TECHNICAL MEMORANDUM

DATE: February 23, 2024

SUBJECT: *1D Model Simulation of Subsidence in Northwest MZ-1—Subsidence Management Alternative #1 (FINAL)*

APPENDIX A – RESPONSES TO GLMC COMMENTS24

Figure 2. PX Site: CVM Layers, Borehole Lithology, 1D Model Cells, and Resistivity Log

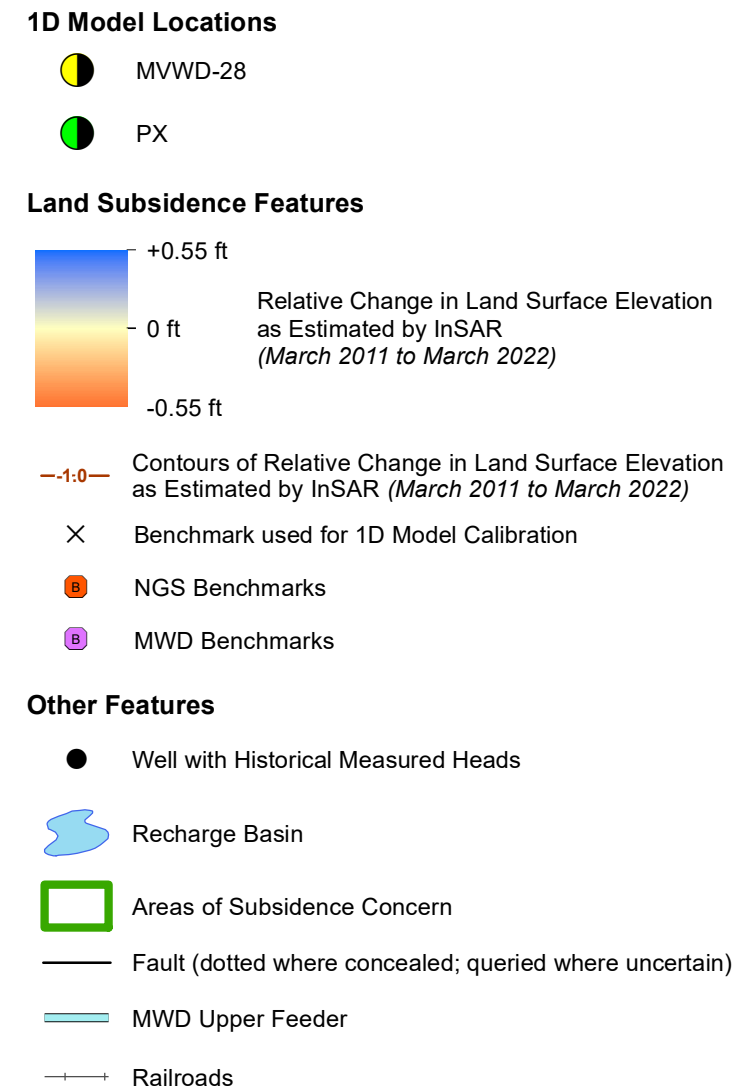
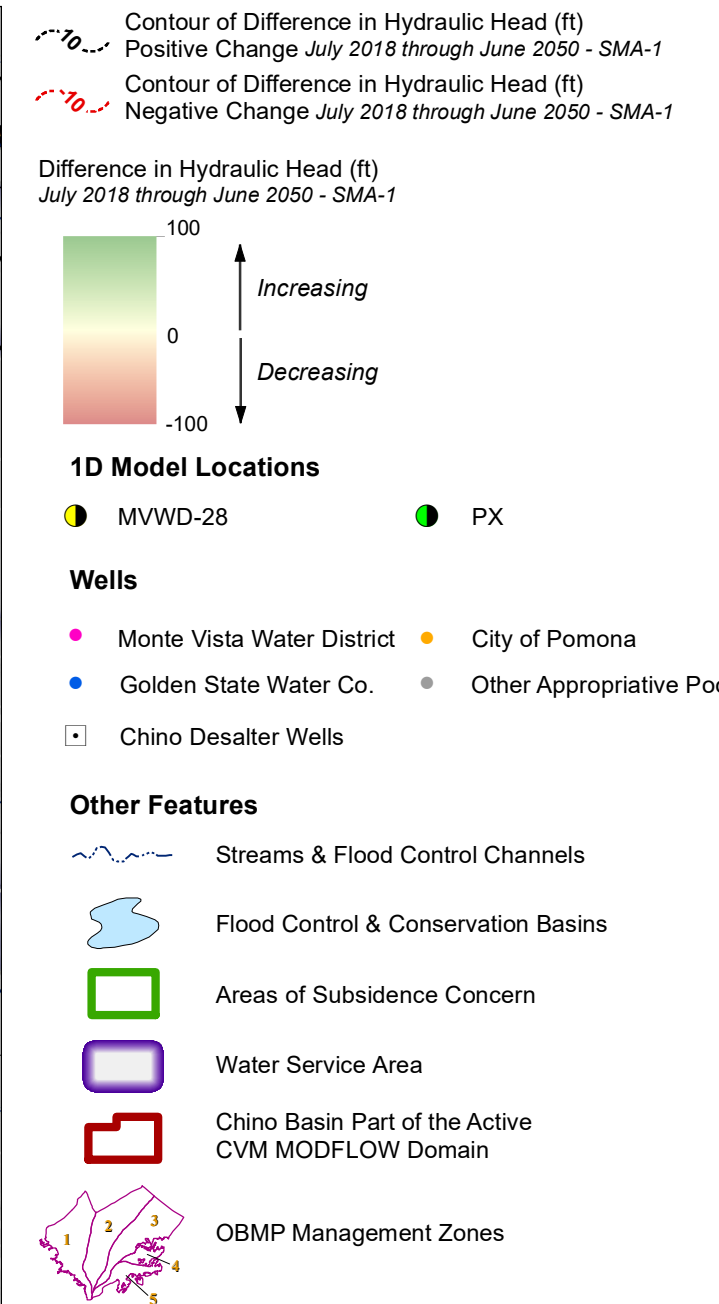
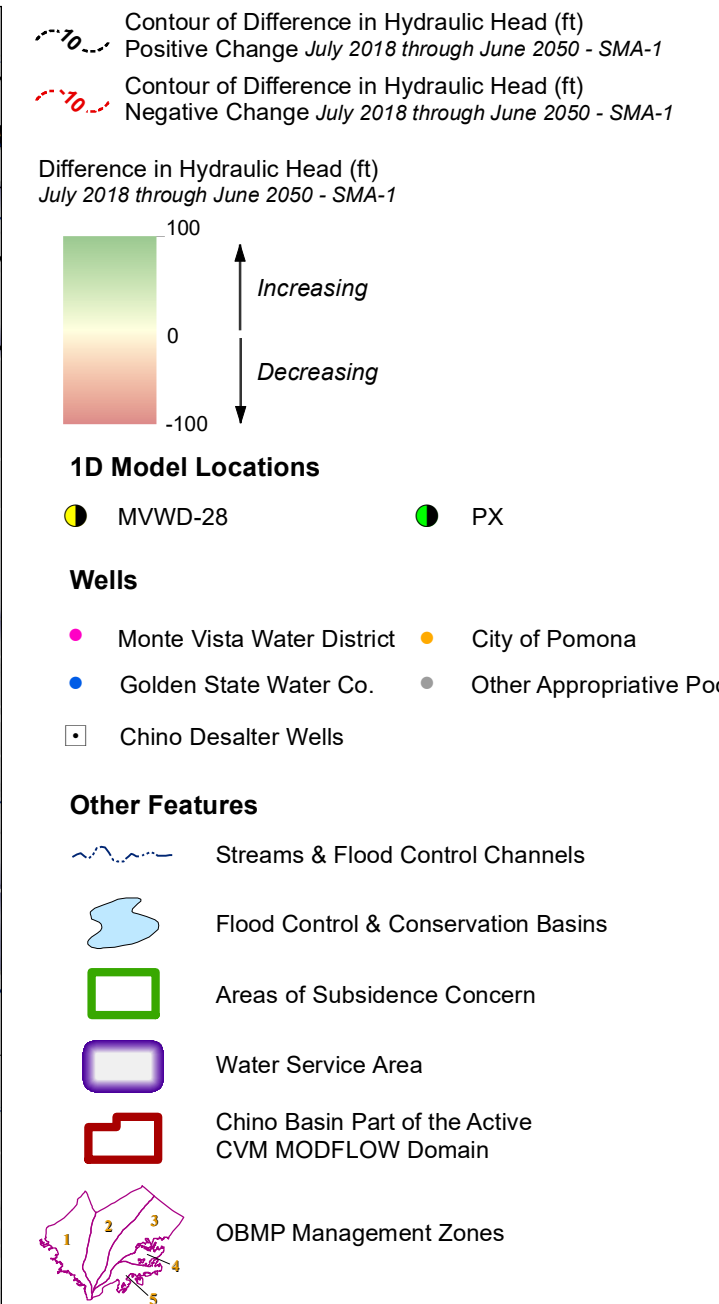
Comment 13 – Figures 2 and 3

How does the simplification of the logs into clay and sand units in the 1-D Model affect the delayed depressurization the model is showing? Does the conceptualization of the clay units exaggerate the delayed depressurization? The distribution of the clay is quite different between the two locations (see differences between MVWD-28 and PX locations), and the presence of interbedded sand should tend to decrease the likelihood of delayed depressurization/compaction.

Numerical models are always a simplification of the natural world. However, model calibration is designed to quantify the ability of a model to simulate historical monitoring data. These 1D Models have been sufficiently calibrated to historical measurements of vertical ground motion. Therefore, we do not believe the 1D Models are “exaggerating” aquitard compaction.

The underlying geology is different between the two 1D Model locations, which in part, accounts for the differing degrees of aquitard compaction as simulated by the 1D Models and land subsidence as shown by the monitoring data.

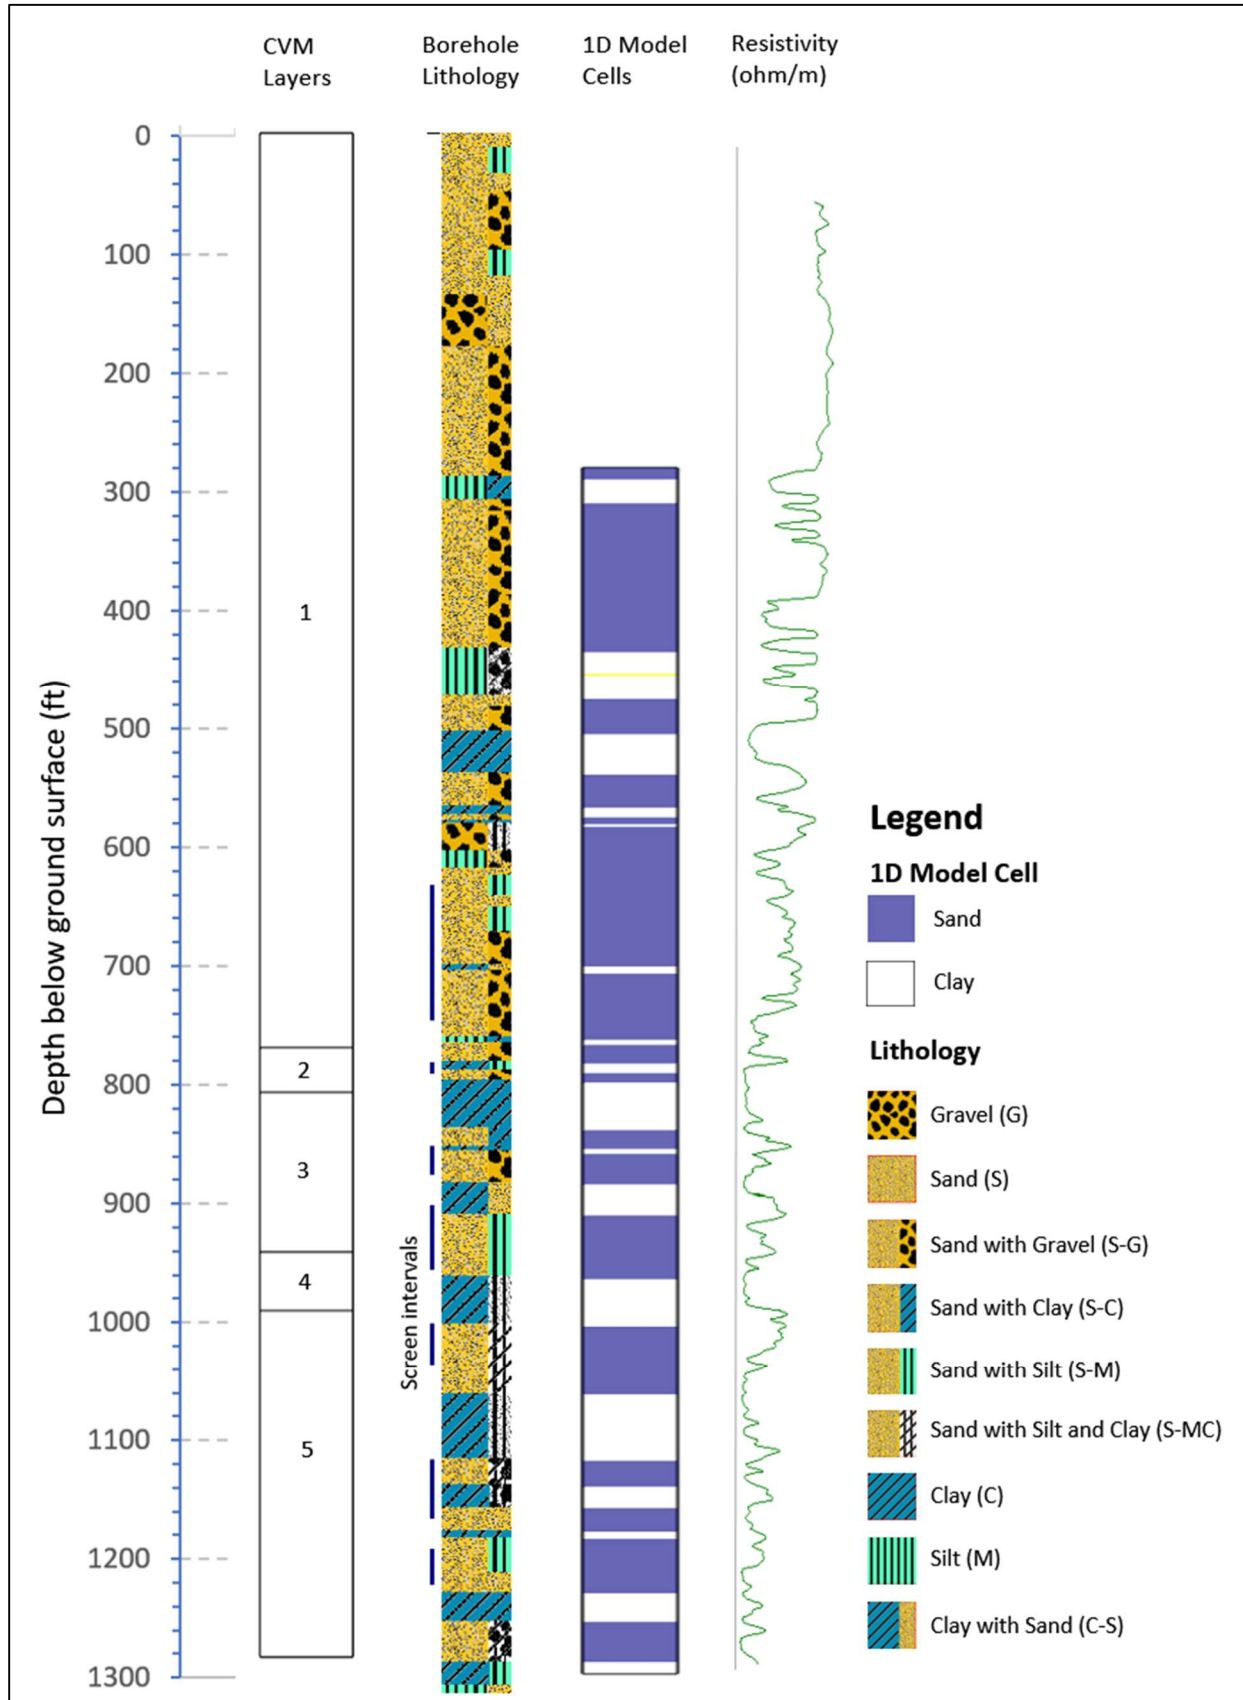
Comment 2 – Figure 5

Figure 5 – contours of the negative differences in hydraulic heads south-southeast of the Central MZ-1 are odd, with the negative 10-foot and negative 20-foot contours overlapping. Please verify that this is correctly contoured.

The figure is correctly contoured. The overlapping and terminal contours are an artifact of the Riley Barrier, which is a groundwater barrier within the deep aquifer system that causes abrupt offsets in hydraulic head.

Figure 11. Projected Heads and Modeled Compaction at the PX Site under SMA-1 (2018-2050)

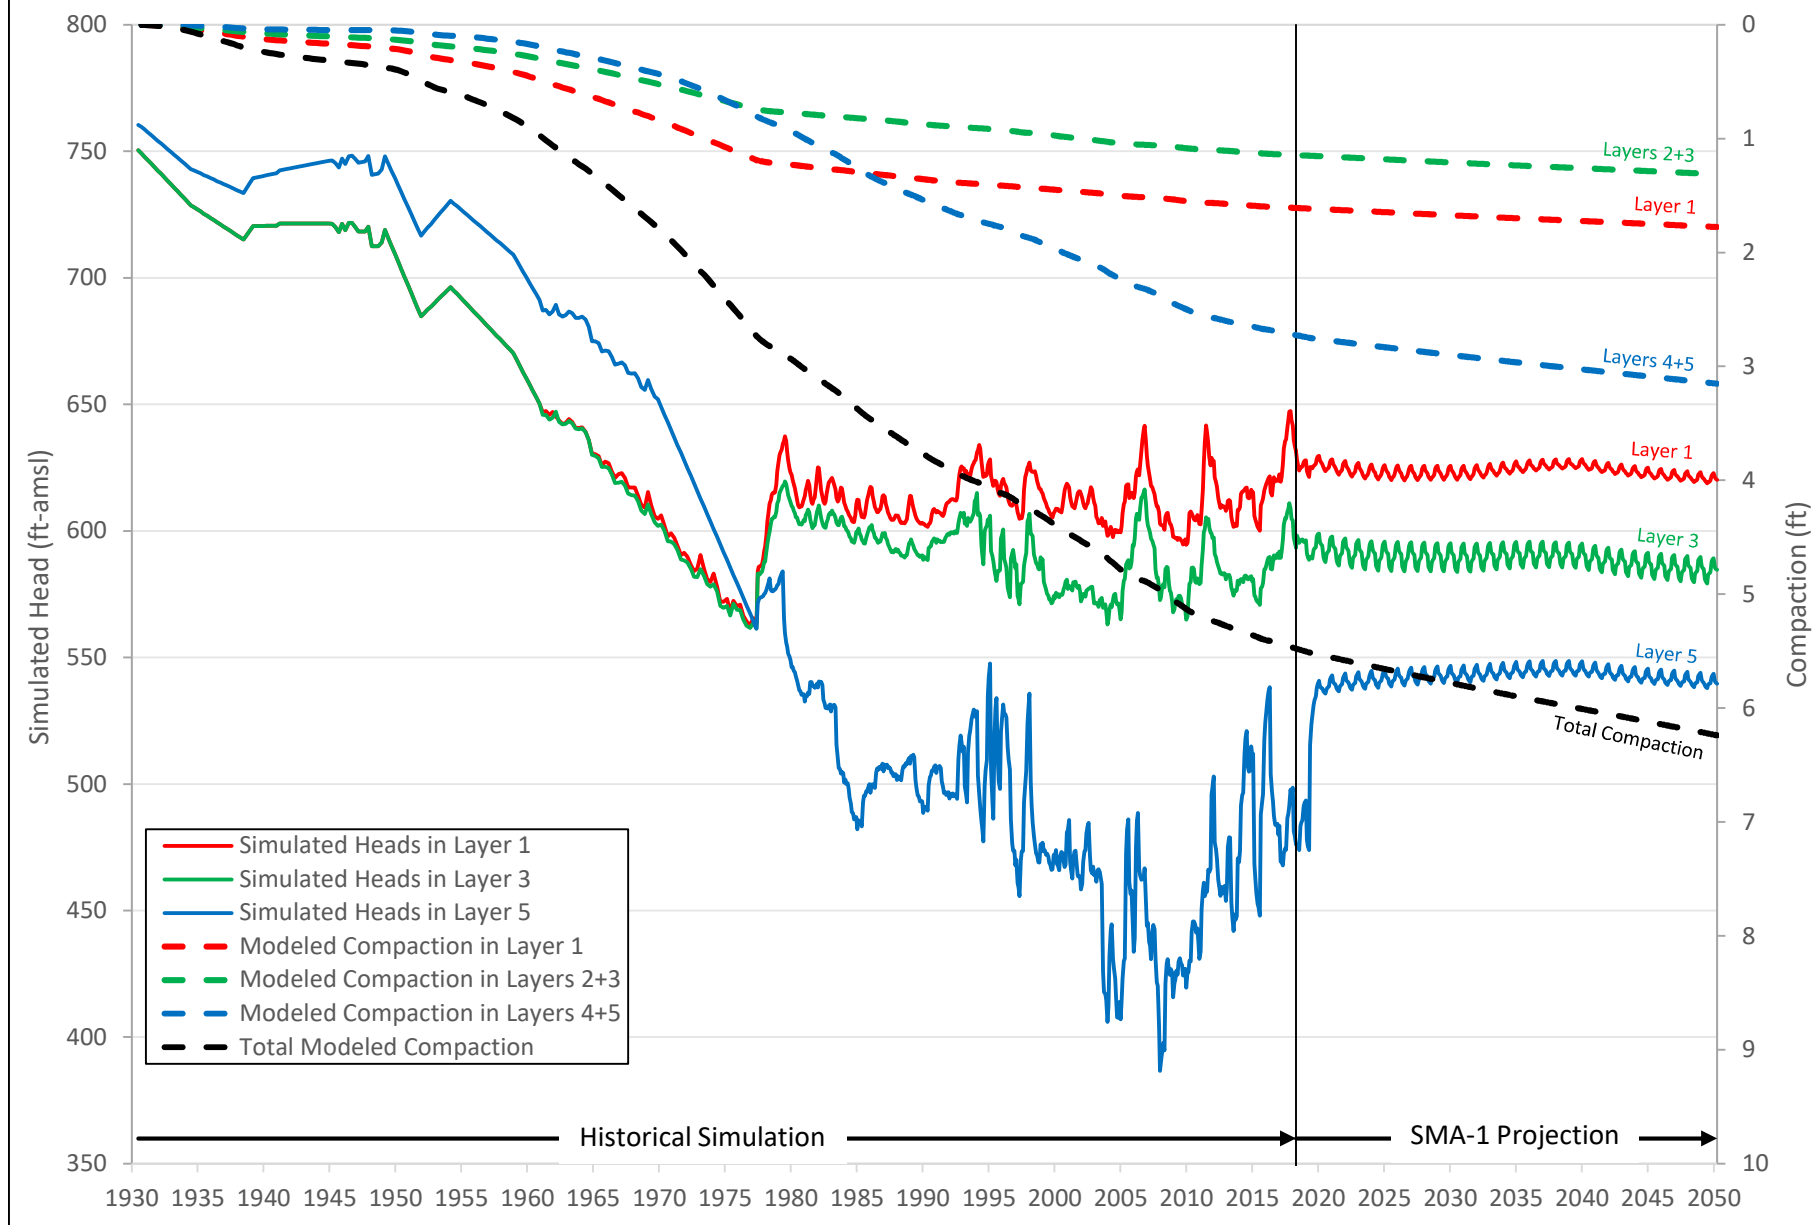
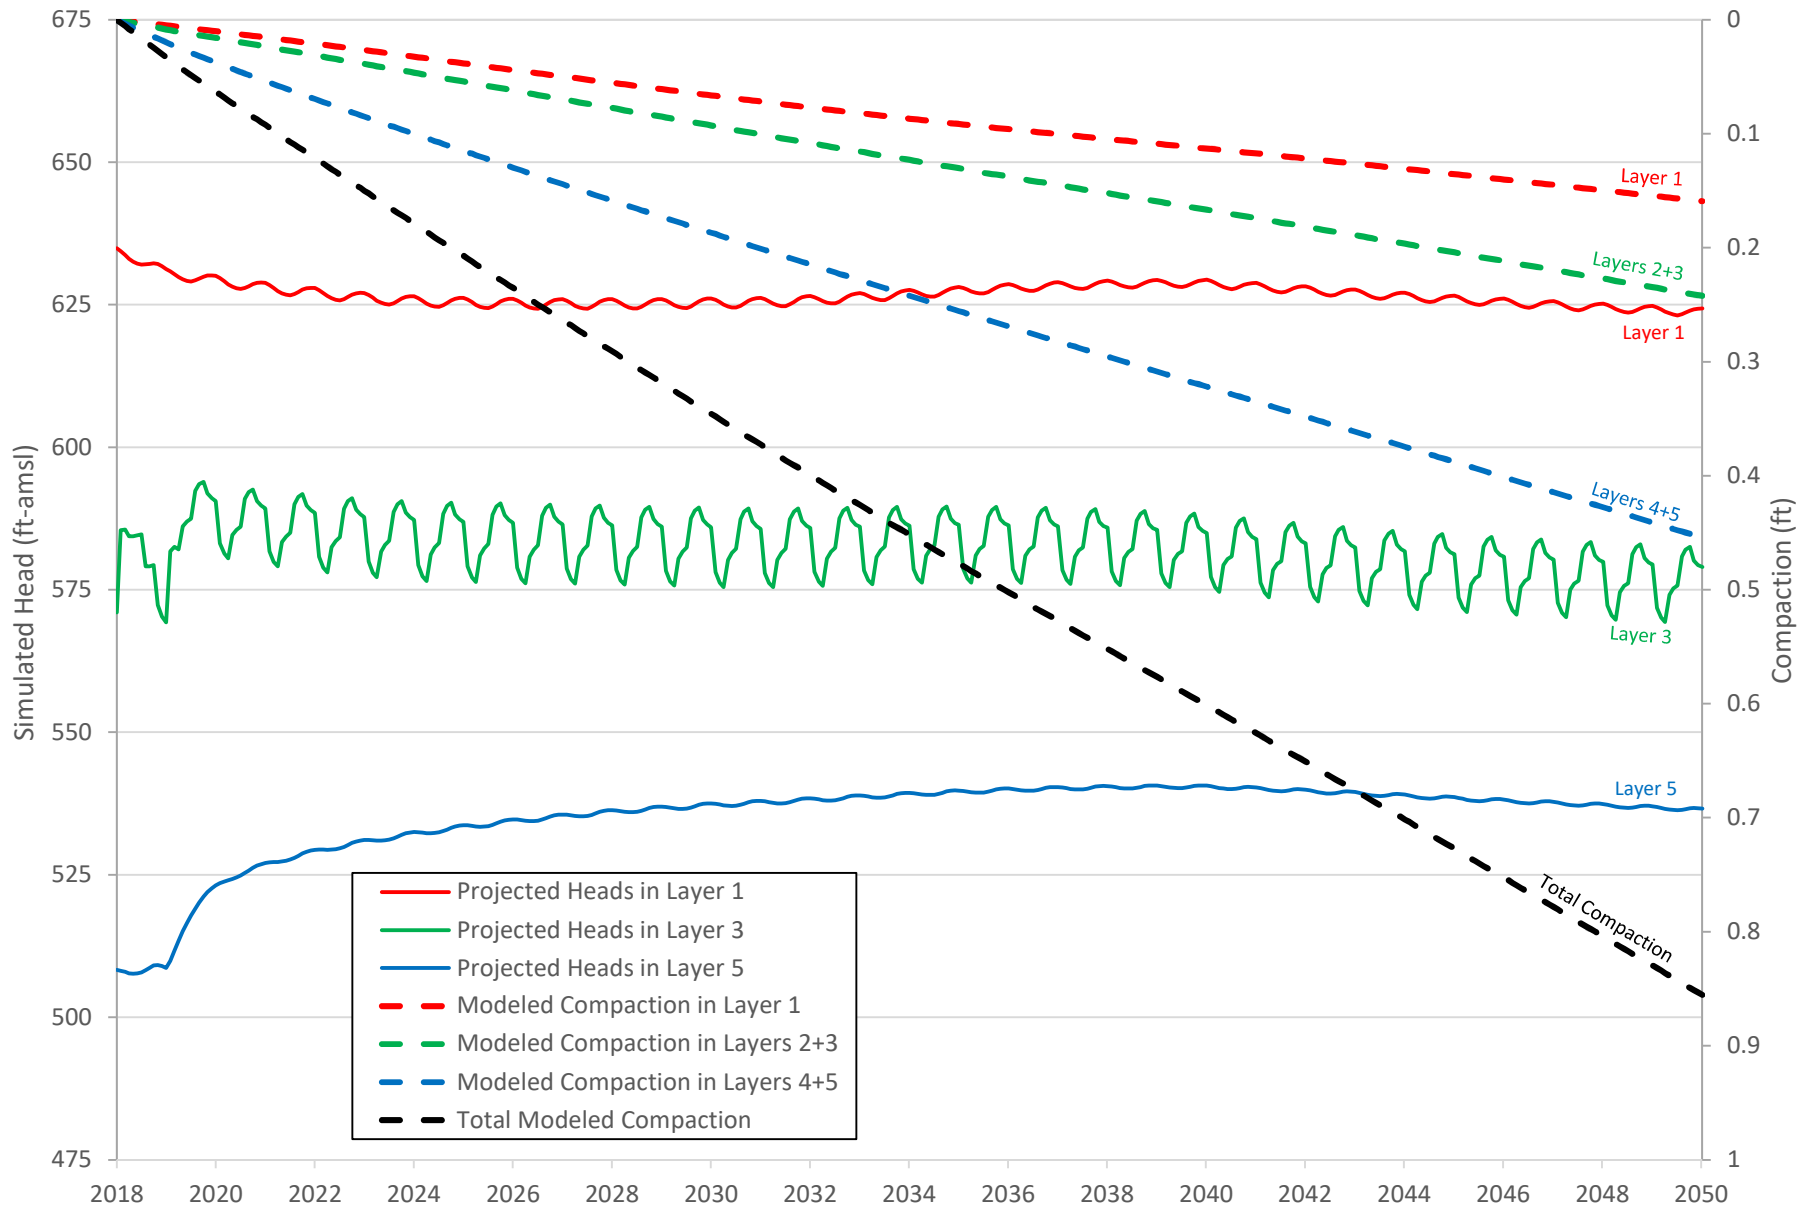
Comment 14 – Figures 11 and 12

Layers 1 and Layer 4 and 5 modeled compaction are very similar between the two sites (MVWD-28 and PX), with Layer 2+3 compaction accounting for most of the difference in the projected compaction. In the lithology logs in Figures 2 and 3, the PX site has significantly more clay relative to the MVWD-28 site in Layers 1 and Layer 4 and 5. What explains the lack of difference in projected compaction in these layers between the sites given how different the lithology is between the two sites?

This observation has not been investigated in detail. During 1D Model calibration, there was a significant difference between total simulated compaction from 1930-2018 at the PX (about 9 ft) compared to total simulated compaction at MVWD-28 (about 6 ft).

The observation that projected compaction from 2019-2040 is similar between the two 1D Models, suggests that the delayed drainage and compaction of aquitards is occurring preferentially in various thicker aquitards at each location. However, no analyses have been performed to verify this hypothesis. This is a potential subject of future study and possible incorporation into the 1D Models and/or Guidance Level.
